Subject: Issuance of Amendment No. 36 to Facility Operating License NPF-10
and Amendment No. 25 to Facility Operating License NPF-15
San Onofre Nuclear Generating Station, Units 2 and 3

ISSUANCE OF AMENDMENT NO. 36 TO FACILITY OPERATING LICENSE NPF-10
AND AMENDMENT NO. 25 TO FACILITY OPERATING LICENSE NPF-15
SAN ONOFRE NUCLEAR GENERATING STATION, UNITS 2 AND 3

SAFETY EVALUATION

SAN ONOFRE NUCLEAR GENERATING STATION, UNITS 2 & 3

Figure 3.1-1

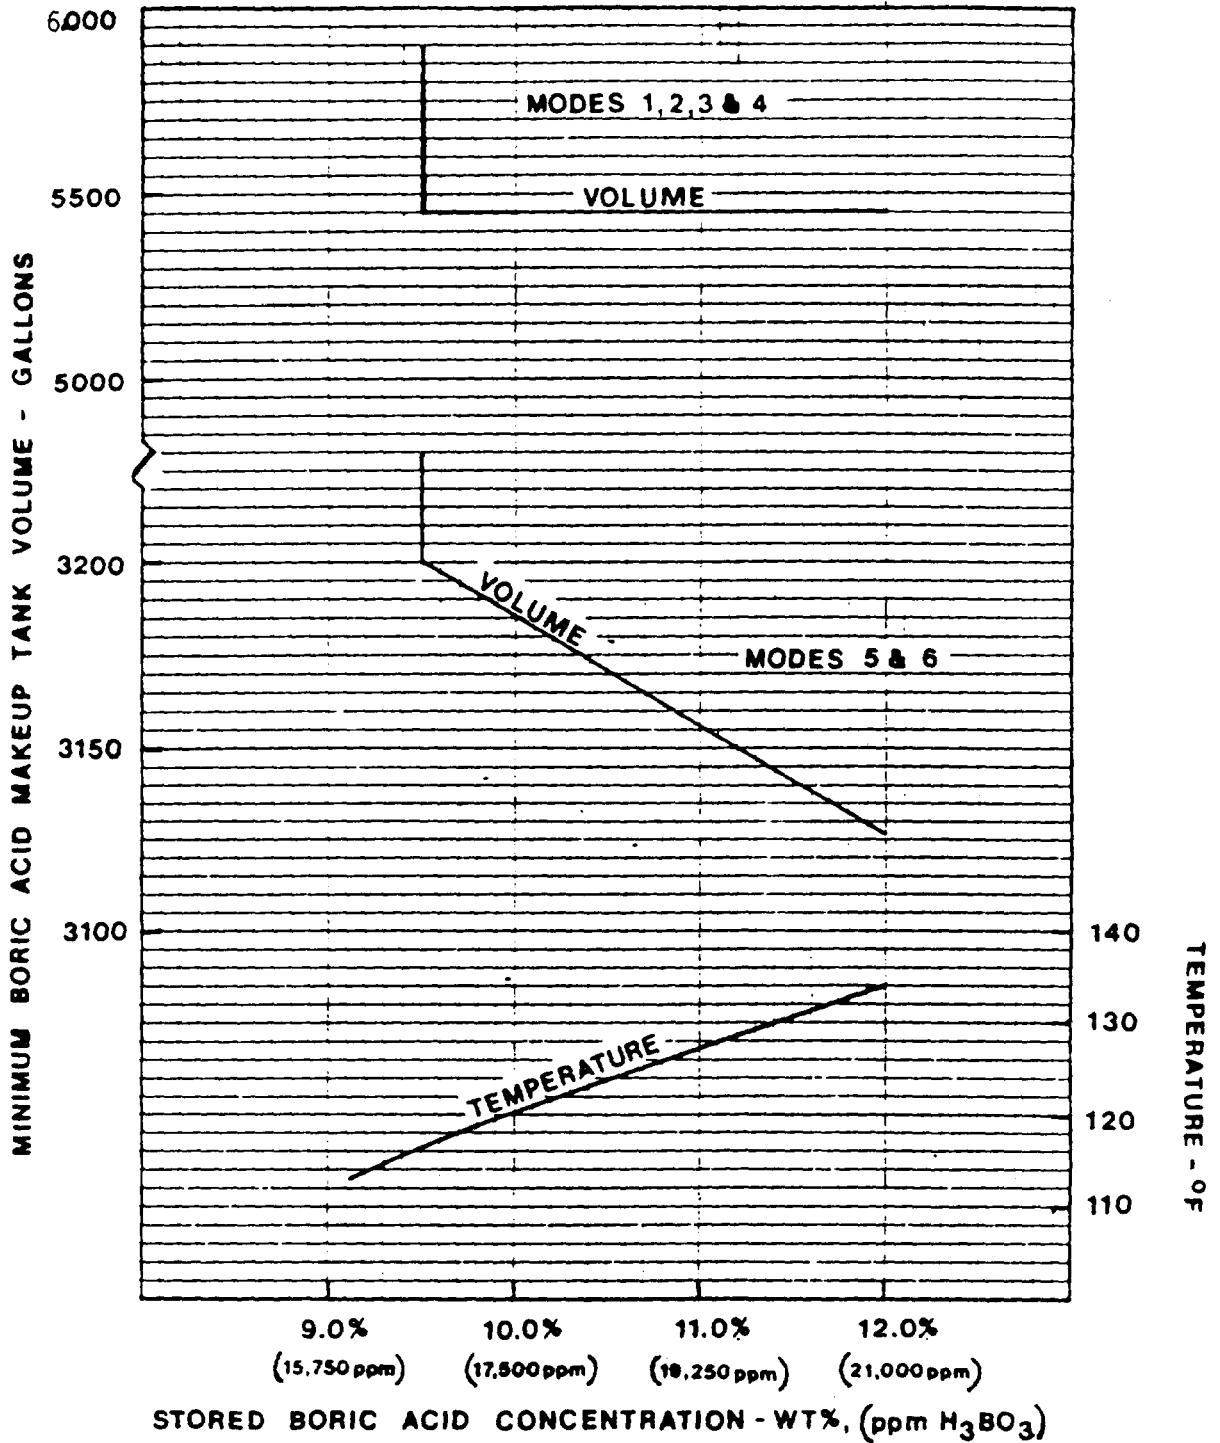
By letter dated May 9, 1985, SCE requested that the NRC staff revise San Onofre Unit 3 Technical Specifications 3.1.2.7, 3.1.2.8, and Bases 3/4.1.2 (PNC-163). Technical Specifications 3.1.2.7 and 3.1.2.8 require borated water source operability and specify volume, temperature and boron concentration requirements which assure that sufficient negative reactivity control is available during each mode of facility operation. These technical specifications define the minimum boric acid concentration. The amendment increases the boric acid storage tank volume/concentration and the minimum refueling water storage tank water volume specified by Technical Specification 3.1.2.7, consistent with the revised safety analysis associated with plant refueling and cycle 2 operation. In addition, the amendment decreases the boric acid storage tank water volume/concentration specified in Technical Specification 3.1.2.8, but nevertheless maintains the reactivity control required for cycle 2 operation, as is demonstrated by the cycle 2 safety analysis.

Core performance analyses of the cycle 2 reactor fuel management design show that the boron concentration required to (1) maintain the required shutdown margin after xenon decay and cooldown to 200°F, and (2) satisfy GDC-26, has increased due to the differences in core design and core performance characteristics from cycle 1. As a consequence, the minimum borated water volume in the refueling water storage tanks and the minimum boric acid makeup tank water volume must be revised for cycle 2 operation in order to meet the limiting conditions for operation on shutdown margin. The minimum water volume required in the boric acid makeup tank and refueling water storage tank in Modes 5 and 6 has been increased due to the increased Mode 5 shutdown margin required for cycle 2 operation. In addition, the Modes 1 through 4 boric acid makeup tank water volume requirement has been decreased in order to facilitate plant operation while nevertheless providing the required shutdown margin. For cycle 1 operation, borated water from the boric acid storage tank was used during plant shutdown to provide makeup for reactor coolant system (RCS) shrinkage. Makeup for RCS shrinkage during cycle 2 will be provided from the refueling water storage tank.

- a. One boric acid makeup tank and at least one associated heat tracing circuit with the tank contents in accordance with Figure 3.1-1.
- b. The refueling water storage tanks with:
 1. A minimum borated water volume of 9970 gallons above the ECCS suction connection,
 2. A minimum boron concentration of 1720 ppm, and
 3. A solution temperature between 40°F and 100°F.

- 3.1.2.8 Each of the following borated water sources shall be OPERABLE:
- a. At least one boric acid makeup tank and at least one associated heat tracing circuit with the contents of the tanks in accordance with Figure 3.1-1, and
 - b. The refueling water storage tank with:
 1. A minimum contained borated water volume of 362,800 gallons above the ECCS suction connection,
 2. Between 1720 and 2300 ppm of boron, and
 3. A solution temperature between 40°F and 100°F.

Therefore, the proposed Technical Specifications 3.1.2.8 and B3/4.1.2 would specify the boric acid storage tank water volume/concentration and the refueling water storage tank volume required for negative reactivity control to be consistent with the requirements of cycle 2 operation. On this basis, the NRC staff finds the proposed change to be acceptable.
